# Access Audit Site Report

**Lake Tawakoni State Park**  
**10822 FM 2475**  
**Wills Point, TX 75169**  
**Accessibility Evaluation**  
**Inspection Date: 09/14/2022**  
**Inspectors: Tanya Scheibe**

Prepared By  
**WT Group**

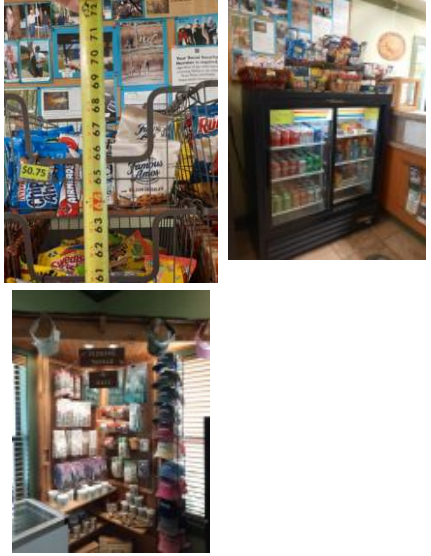
Finding Number	Area Description	Lat/Long	Finding	As Built	Recommendation	Citation	Photos	Figure
5	Headquarters Area: HQ Parking	[32.8421332 , -95.993707 5]	The parking stall contains abrupt edges and surface irregularities over a 1/4 inch vertical. Parking spaces and access aisles serving them shall be stable, firm, and slip resistant. Access aisles shall be at the same level as the parking spaces they serve. Changes in level are not permitted and shall not be sloped steeper than 2% in any direction.	Gaps, CILs, and depressions in all stalls and access aisles; loose gravel, sand, and dried mud in accessible spaces; deterioration of striping causing gaps - recommend resurface	Resurface stalls and access aisles to eliminate gaps and cracks.	2015 ABAAS Section: 502.4 2012 TAS Section: 502.4 2010 ADAS Section: 502.4

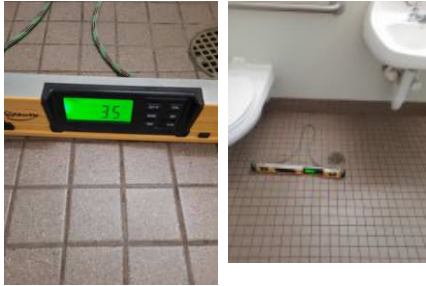
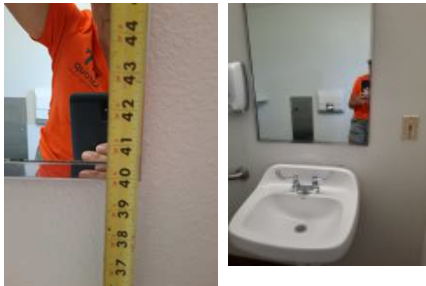
9	Headquarters Area: HQ Exterior Accessible Route	[32.8419472 , -95.993721 3]	The running slope of walking surfaces shall not be steeper than 1:20. The cross slope of walking surfaces shall not be steeper than 1:48.	2.4% cross slope between restrooms	Correct running slopes to max 5% and cross to max 2.08%.	2012 TAS Section: 403.3  2010 ADAS Section: 403.3		
10	Headquarters Area: HQ Exterior Accessible Route	[32.8421044 , -95.993681 4]	The curb ramp slope exceeds the maximum running slope (direction of travel) allowable of 8.33%. Curb ramps should have the least possible slope but in no case more than 8.3% (1:12).	Park entry side curb ramp at access aisle - 8.9% running slope	Correct curb ramp slope to max 8.33%.	2015 ABAAS Section: 406.1  2012 TAS Section: 406.1  2010 ADAS Section: 406.1

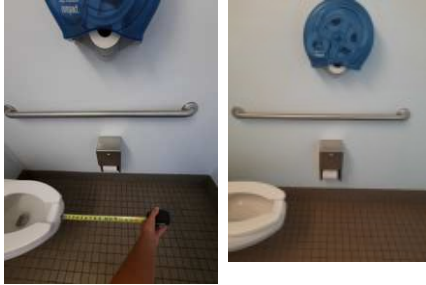
Finding Number	Area Description	Lat/Long	Finding	As Built	Recommendation	Citation	Photos	Figure
18	Headquarters Area: HQ Restrooms	[32.8419056 , -95.993667 1]	The accessible route contains running slopes greater than 5 percent and cross slopes greater than 2 percent across the width of the walk and has not been constructed as a ramp (i.e. handrails, wheel guides, etc.). When the slope in the direction of travel of any walk exceeds 1 unit vertical in 20 units horizontal (5-percent slope), it must be constructed as ramp. Surface cross slopes must not exceed one unit vertical in 48 units. Horizontal (2-percent slope).	Left - 3.5% at drain	Correct or repair slope to max 2.08% in restroom.	2015 ABAAS Section: 403.3  2012 TAS Section: 403.3  2010 ADAS Section: 403.3		
19	Headquarters Area: HQ Restrooms	[32.8419045 , -95.993671 1]	The mirror is mounted too high. Mirrors must have the bottom edge of the reflecting surface a maximum of 40 inches above the floor if above a sink or counter. Mirrors not located above lavatories or countertops shall be installed with the bottom edge of the reflecting surface 35 inches maximum above the finish floor or ground.	Left - 40.5" to mirror	Lower mirror so bottom reflective surface is max 40" AFF and 74" at the top.	2015 ABAAS Section: 603.3  2012 TAS Section: 603.3  2010 ADAS Section: 603.3

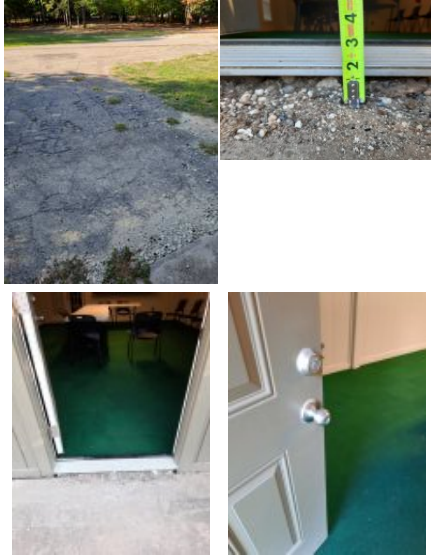
Finding Number	Area Description	Lat/Long	Finding	As Built	Recommendation	Citation	Photos	Figure
38	Employee Spaces: Maintenance	[32.8414159, -95.99521]	Stairways must have handrails on both sides. Handrails and their extensions must be between 34 inches and 38 inches above the stair nosing or ground. The top handrails shall extend a minimum of 12 inches beyond the top nosing and shall be parallel with the floor or ground surface. At the bottom of a stair flight, handrails shall extend at the slope of the stair flight for a horizontal distance at least equal to one tread depth beyond the last riser nosing. Extension shall return to a wall, guard, or the landing surface, or shall be continuous to the handrail of an adjacent stair flight. The orientation of at least one handrail, including the extension, shall be in the direction of the run of the stair and perpendicular to the direction of the stair nosing. Handrail gripping surfaces with a circular cross section shall have an outside diameter of 1-1/4 inches minimum and 2 inches maximum. Handrail gripping surfaces with a non-circular cross section shall have a perimeter dimension of 4 inches minimum and 6 1/4 inches maximum, and a cross-section dimension of 2-1/4 inches maximum. The hand grip portion of handrails shall have a smooth surface with no sharp corners. Gripping surfaces (top or sides) shall be uninterrupted by newel posts, other construction elements or obstructions. Any wall or other surface adjacent to the handrail shall be free of sharp or abrasive elements. Handrails projecting from a wall shall have a space of 1-1/2 inches minimum between the wall and the handrail.	Stairs at laundry lacks compliant handrails	Install handrails on both sides of stairway, mounted 34" to 38" AFF with top and bottom extensions and having a 1.25" – 2" in diameter, or a non-circular grip that has a perimeter dimension of 4"- 6.25" max with a min gap of 1.5" between handrail and wall.	2015 ABAAS Section: 505.2  2012 TAS Section: 505.2  2010 ADAS Section: 505.2

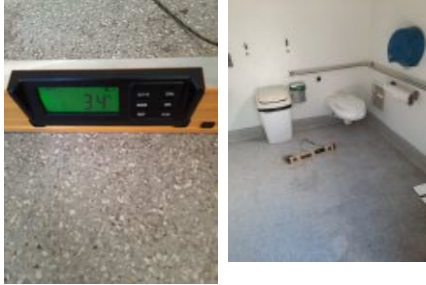
Finding Number	Area Description	Lat/Long	Finding	As Built	Recommendation	Citation	Photos	Figure
58	White Deer Reach Camping Loop: WDR - South Unisex Restroom Left	[32.8464467 , -95.991566 4]	The bottom 10 inches on the push side must be smooth and free of obstructions (hold open devices). Opening hardware must be mounted between 30 and 44 inches above the floor or ground.	WDR South restroom Left door - hold open device on push side	For all doors along the public circulation route, remove door holder to provide a smooth surface on the push side of door from floor to 10" AFF.	2010 ADAS Section: 404.2.3, 404.2.7, 404.2.4, 404.2.11, 404.2.11 Exception		
59	White Deer Reach Camping Loop: WDR - South Unisex Restroom Left	[32.8464486 , -95.991568 1]	The water and drain pipes under the lavatory are not adequately insulated. Water supply and drain pipes under lavatories and sinks shall be insulated or otherwise configured to protect against contact. There shall be no sharp or abrasive surfaces under lavatories and sinks.	Sink lacks insulated pipes	Insulate exposed pipes under one sink.	2015 ABAAS Section: 606.5  2012 TAS Section: 606.5  2010 ADAS Section: 606.5

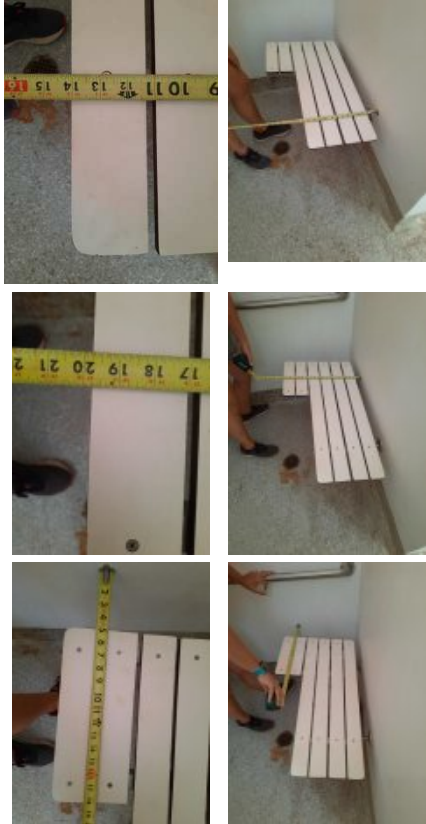
Finding Number	Area Description	Lat/Long	Finding	As Built	Recommendation	Citation	Photos	Figure
82	White Deer Reach Camping Loop: WDR - North Unisex Restroom Left	[32.8464584 , -95.9915736]	The short section of the "L" shaped seat must be located closest to the wall nearest the controls. The rear edge of an L-shaped seat shall be 2 1/2 inches maximum and the front edge 15 inches minimum and 16 inches maximum from the seat wall. The rear edge of the "L" portion of the seat shall be 1 1/2 inches maximum from the wall and the front edge shall be 14 inches minimum and 15 inches maximum from the wall. The end of the "L" shall be 22 inches minimum and 23 inches maximum from the main seat wall.	Shower seat lacks compliant mounting dimensions	Remount shower seat to the correct location and height in the shower.	2015 ABAAS Section: 610.3.2  2012 TAS Section: 610.3.2  2010 ADAS Section: 610.3.2

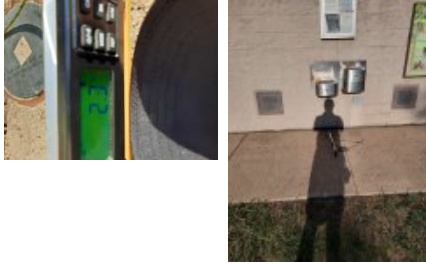
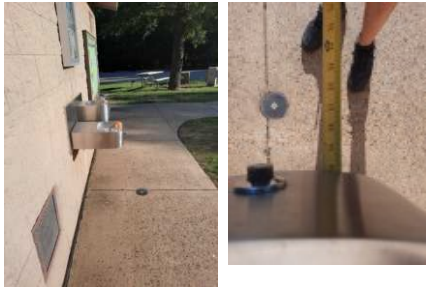
87	White Deer Reach Camping Loop: WDR - North Unisex Restroom Right	[32.8464415 , -95.991576 1]	The required 56 inches by 60 inches clear floor space for the water closet has been obstructed. The clear floor space around the water closet shall be 60 inches minimum measured perpendicular from the side wall and 56 inches minimum measured perpendicular from the rear wall.	Garbage can within clearance of toilet	Remove or relocate garbage can to provide required 60" clearance around toilet.	2015 ABAAS Section: 604.3.  2012 TAS Section: 604.3.1  2010 ADAS Section: 604.3.1

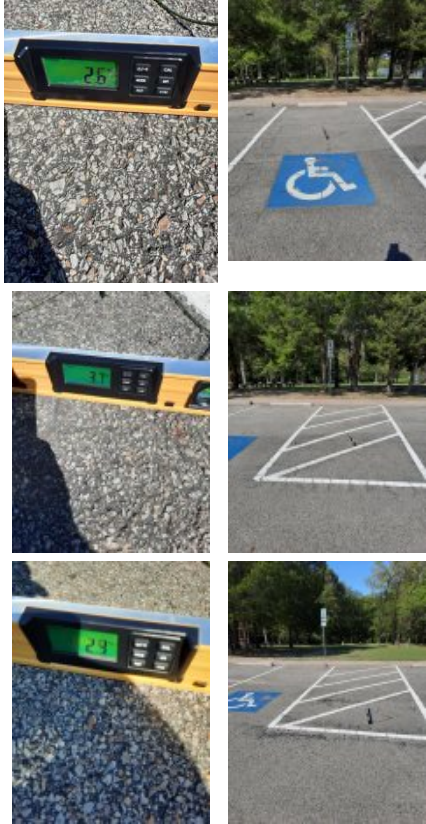
Finding Number	Area Description	Lat/Long	Finding	As Built	Recommendation	Citation	Photos	Figure
162	Day Use Area: Day Use - Farkleberry Trailhead	[32.84552, -95.99429]	An accessible access route is not provided between elements, spaces and the facilities provided within the accessible camping unit. At least one outdoor recreation access route shall connect accessible elements, spaces and facilities provided within camping units with mobility features.	Farkleberry Trail Trailhead - lacks ORAR to trailhead	Create AR with crushed and compacted stone or similar outdoor material to camp sites and one of each type of amenity.	2015 ABAAS Section: F244.5.1		
163	Day Use Area: Day Use - Farkleberry Trailhead	[32.84572, -95.99423]	The surface of trails, passing spaces, and resting intervals shall be firm and stable	Farkleberry Trail lacks firm and stable surface - natural surface; leads to Osage Orange (.8), Red Oak (.4) and BlackJack (1.5)	Replace trail surface to be firm and stable. In the alternative, leave as is and designate other trails in the park as accessible.	2015 ABAAS Section: 1017.2

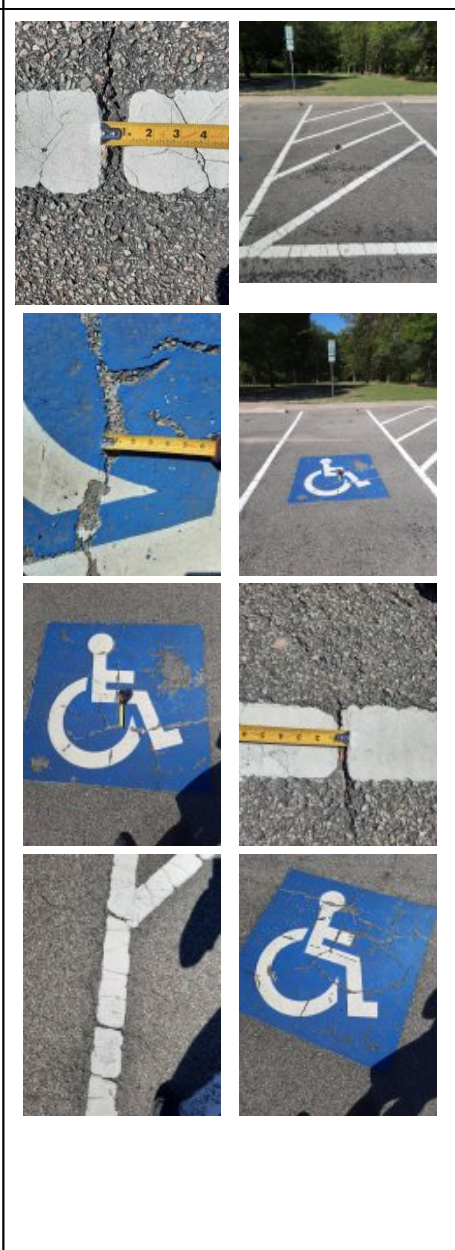
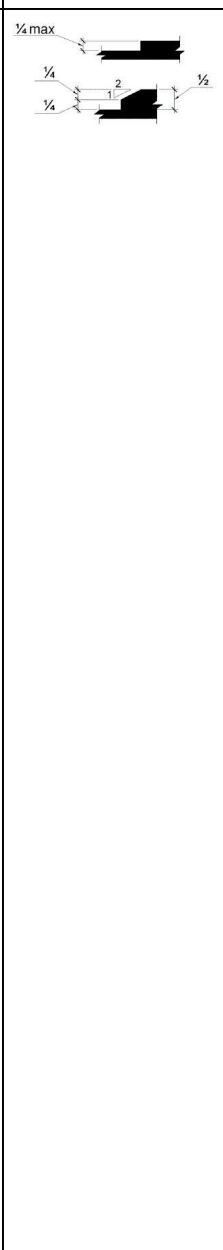
167	Day Use Area: Day Use - Parking	[32.8475, -95.993862 8]	The accessible route is constructed such that a park vehicle can obstruct the minimum 36 inch width. Parking spaces and access aisles shall be designed so that cars and vans, when parked, cannot obstruct the required clear width of adjacent accessible routes.	Parking bumper too close to front of stall, cars could overhang accessible route	Relocate parking bumpers at entry to AR to prevent cars from blocking AR.	2015 ABAAS Section: 502.7  2012 TAS Section: 502.7  2010 ADAS Section: 502.7		
168	Day Use Area: Day Use - Parking	[32.84754, -95.99453]	Element meets all standards and requirements	Picnic area parking - 19 standard stalls, 2 accessible	None	2010 ADAS Section: N/A

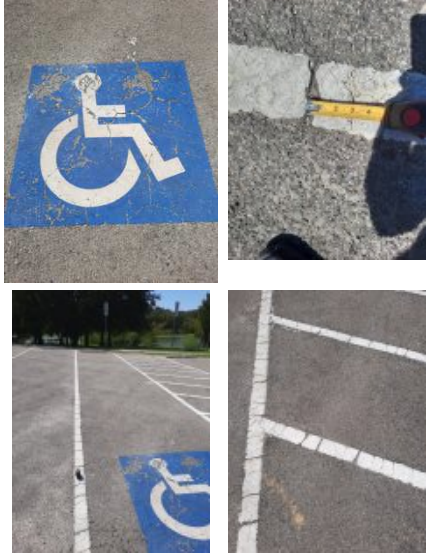
Finding Number	Area Description	Lat/Long	Finding	As Built	Recommendation	Citation	Photos	Figure
232	Day Use Area: Day Use - Picnic Areas	[32.84855, -95.9957]	Openings in the surface of outdoor recreation access routes shall not allow the passage of a sphere more than 1/2 inch (13 mm) in diameter. Advisory: Spaces between the boards in a boardwalk and drainage grates are examples of openings. Where possible, drainage grates should be located outside the minimum clear width of the outdoor recreation access route. Elongated openings should be placed so that the long dimension is perpendicular, or as close to perpendicular as possible, to the dominant direction of travel	Four gaps of 1" on the four sides of the accessible picnic table at accessible picnic space near beach	Correct or fill gaps along the ORAR to max .5" as a smart practice.	2015 ABAAS Section: 1016.6, Advisory 1016.6		
233	Day Use Area: Day Use - Picnic Areas	[32.84856, -95.99576]	The 30 inches minimum by 48 inches minimum clear floor space required at the operable part is not flat (2% or 1:48 maximum slope) in all directions. Changes in level are not permitted at required clear floor or ground space except that slopes not steeper than 1:48 shall be permitted.	Slope of 2.3% in clear ground space (CGS) of accessible picnic table at accessible picnic space near beach	Correct or repair slope in CFS to max 2.08%.	2015 ABAAS Section: 305.2  2012 TAS Section: 305.2  2010 ADAS Section: 305.2

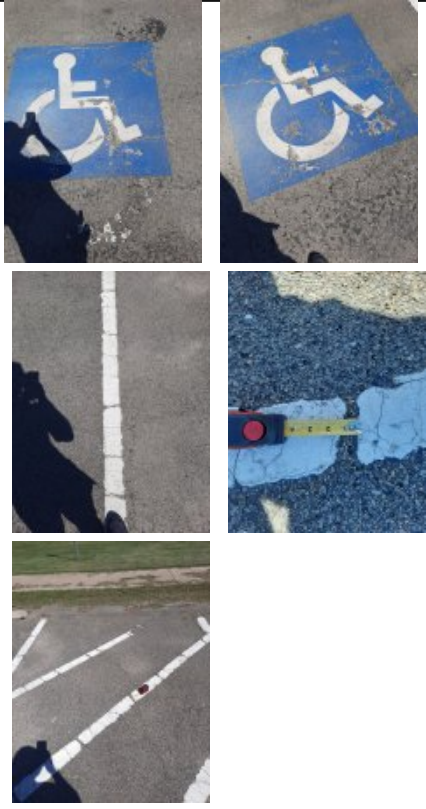
Finding Number	Area Description	Lat/Long	Finding	As Built	Recommendation	Citation	Photos	Figure
244	Day Use Area: Day Use - Boat Ramp	[32.8481983 , -95.994673 1]	The accessible route contains running slopes greater than 5 percent and cross slopes greater than 2 percent across the width of the walk and has not been constructed as a ramp (i.e. handrails, wheel guides, etc.). When the slope in the direction of travel of any walk exceeds 1 unit vertical in 20 units horizontal (5-percent slope), it must be constructed as ramp. Surface cross slopes must not exceed one unit vertical in 48 units. Horizontal (2-percent slope).	Cross slope of 2.6% on beach side of cleaning table, 2.6% on entry walkway side	Correct or repair slope to max 5% running and 2.08% cross.	2015 ABAAS Section: 403.3  2012 TAS Section: 403.3  2010 ADAS Section: 403.3		
245	Day Use Area: Day Use - Boat Ramp	[32.8481994 , -95.994666 4]	The operable part is not accessible because it requires tight grasping, pinching or twisting of the wrist. The force required to operate the element exceeds the maximum. The force required to activate operable parts is 5 pounds maximum.	Fish cleaning - Water spigot handles and hose handle require tight pinch or grasp (difficult to turn on - over 5# of force)	Replace operable part with one usable without a tight pinch or grasp. Adjust operating mechanism to be usable with 5 lbf or less.	2015 ABAAS Section: 309.4  2012 TAS Section: 309.4  2010 ADAS Section: 309.4
